26th May 2026

Ref: 26.17.01

APPLICATION 260608 - RISELEY RECREATION GROUND, ODIHAM ROAD, RISELEY, RG7 1SD – PROPOSED HEIGHT BARRIER

Scale	Date	Designed	Drawn	Drawing No	Rev	
1:200 @ A3	12 MAY 26	DFM	DFM	26.17 - 002	A

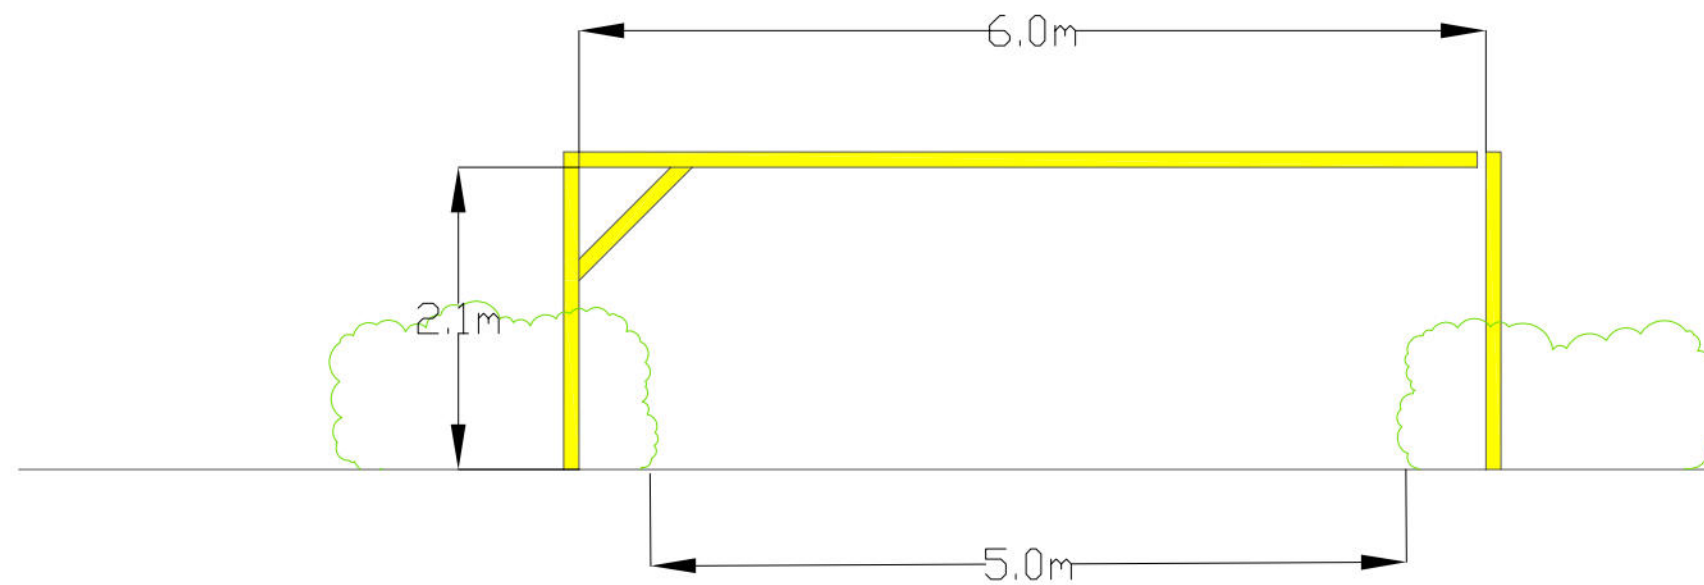
The officer is concerned whether the proposed height barrier will impact upon vegetation and trees. Drawings 26.17 – 002A and 003A provide additional details on the siting and design of the barrier. The barrier will be located inside the site and constructed within the existing tarmac area of the car park. As such, there will be no impact on the vegetation or trees that are located on the highway side of the site boundary. If deemed necessary, a condition relating to the provision of tree protection fencing during the erection of the barrier could be imposed.

Drawings 26.17 – 002A and 003A provide additional details relating to the dimensions of the barrier and the location of the catch pole.

The requested visibility splays are shown on drawing 26.17 – 002A.
